February 2, 1987
LN-87-0035-L18

Enclosed is a draft of our responses to the NRC comments and questions regarding our topical report entitled, "Topical Report on 10 CFR 61 Qualified Radioactive Waste Forms." The responses are intended to answer questions which have been asked by the NRC and to conform the actions which LN must take in order to obtain approval of the report.

RESPONSE TO USNRC COMMENTS ON THE
LN TECHNOLOGIES 10 CFR 61 TOPICAL REPORT

FILTER ENCAPSULATION LINER

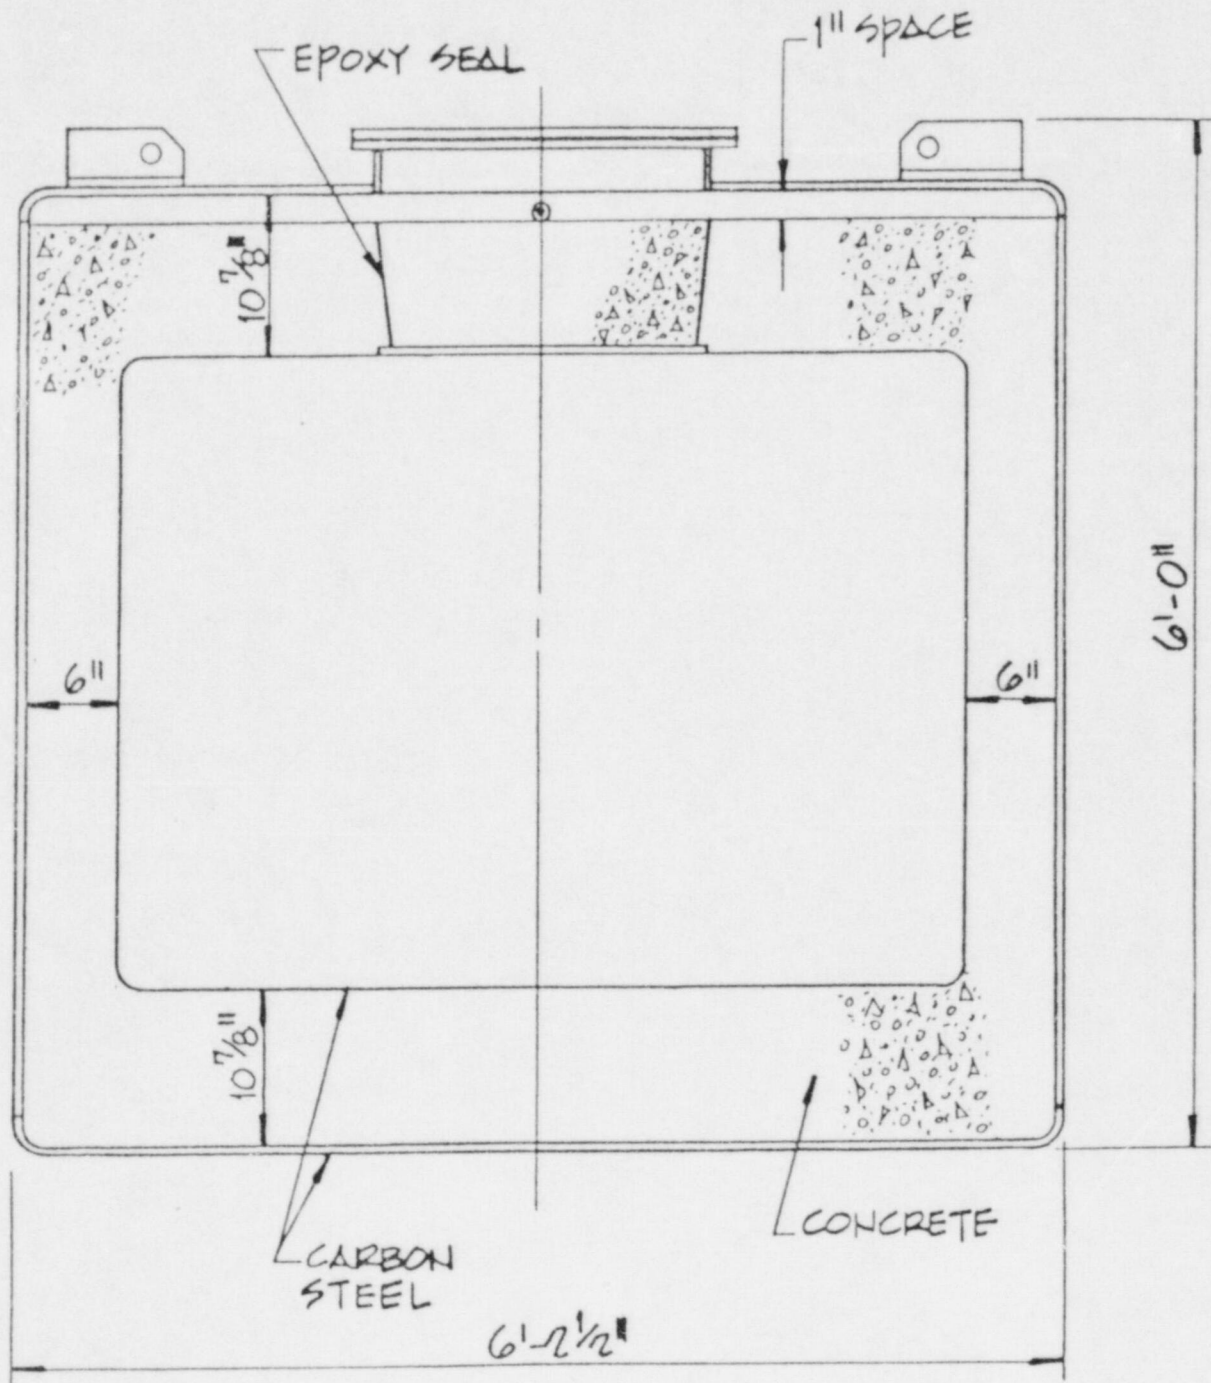
In C.5 of the Technical Position on Waste Form (TP), it is stated that for filter cartridge wastes, the waste generator should demonstrate that the selected approach for providing stability will meet the requirements of 10 CFR Part 61. A structurally stable waste, according to 10 CFR 61.56 "will generally maintain its physical dimensions and form under the expected disposal conditions such as the weight of overburden." Encapsulation of the filter cartridge in a solidification binder, mentioned in the TP as one option for providing stability, has been selected by NUS. Cement grout has been selected as the binder material. NUS presents calculations (in Appendix H of the topical report) of the thickness of the cement encapsulation required to withstand a specified overburden load (45 ft of material of 120 lb/ft³ density). These thicknesses are calculated as a fraction of the compressive strength of the cement. In addition, NUS assumed in these calculations for the sake of conservatism that during encapsulation none of the cement grout flows into the metal cage containing the filter cartridges. NUS maintains that, in actuality, significant volumes of grout will flow into the interior of the metal cage, and thereby, furnish additional structural support to the encapsulated

product. The unquantified additional structural support from cement in the interior of the metal cage is used to justify a safety factor of 1.5 used in calculating the thickness of cement in the top, bottom, and side-wall between the metal cage and the external container.

It is further assumed in making these calculations that the mechanical properties of grout "in tension and flexure" may be "estimated as a ratio for the compressive strength." The ratios used for grout are taken to be the same as those "typically estimated" for concrete. No values for these ratios are cited except $ST/S_c = 0.15$ in connection with failure of container end by shear (in Figure 5 of Appendix H of the Topical Report). It is not clear how this ratio between the tensile and compressive strength is used in the consideration of failure of the container ends by bending as presented in Appendix H (e.g., top drawing in Figure 4). The staff concludes that NUS has not adequately demonstrated that an unreinforced grout shell can support the weight of the overburden. It may prove necessary to incorporate reinforcing structures into the grout material. The staff further concludes that NUS has failed to demonstrate that sufficient additional structural support will be provided by "significant" amounts of grout which will flow into the metal cage containing the filter cartridges. Furthermore, since the cement ends and sidewall are not internally reinforced, NUS should indicate how it will determine, either on a case-by-case basis for each filter encapsulation liner or on a generic basis, that sufficient grout has flowed into the interior of the metal cage to justify use of the 1.5 safety factor. Such a justification should take into account that no credit for structural strength may be taken by the filter cartridges since these may be subject to degradation processes after encapsulation.

Since the grout used for encapsulation is poured onto a bottom slab which is already solidified and set and, in addition, may not necessarily have the same composition as the grout, inadequate bonding between the grout and the bottom slab at the seam separating them may compromise the integrity of the encapsulation. The calculations in Appendix H of the topical report do not take account of the seam between the grout and the bottom of the slab. In addition, the seam may provide a pathway for leaching of radionuclides from the filter cartridges. NUS should demonstrate that the seam will neither compromise the ability of the filter encapsulation liner to withstand the weight of overburden nor provide a pathway for the release of radionuclides.

A detailed description should be given of the method for preparing a liner for encapsulating filter cartridges. The type of materials that would be processed by encapsulation should be listed. The description of the encapsulation method should at least include an explanation of how the liner (with the cement slab) will be prepared.

Note also that the Hanford disposal site has increased the effective disposal depth to 55 ft. The structural calculations, therefore, should be revised for this burial depth.

In order to increase the strength of the filter encapsulation liner, eliminate concerns regarding the seam between the grout and bottom of the slab and to make the container easier and less expensive to use, LN has redesigned the FE liner. Section VI.F and the analysis in Appendix H, which will reflect the new burial depth of 55 feet at Hanford, will be revised.

The new filter encapsulation liner design, shown in the following figure, requires that the container concrete be poured during fabrication at one time, thereby eliminating the seam at the bottom of the liner. A plug is poured separately and placed in the liner opening after the filters are loaded into the liner. An epoxy sealant, commonly used for nuclear applications, is then pumped into the gap between the plug and the concrete of the liner head. The resulting bond is stronger than the base concrete which it seals. The new design is much easier for the utility customer to use as the concrete container is poured during fabrication under controlled conditions rather than after loading with radioactive wastes. In addition, there is no need to mix and transfer the concrete grout at the site, with the potential problem of premature set of the grout if problems occur. The FE liner will be more fully described in the revised section of the topical report.
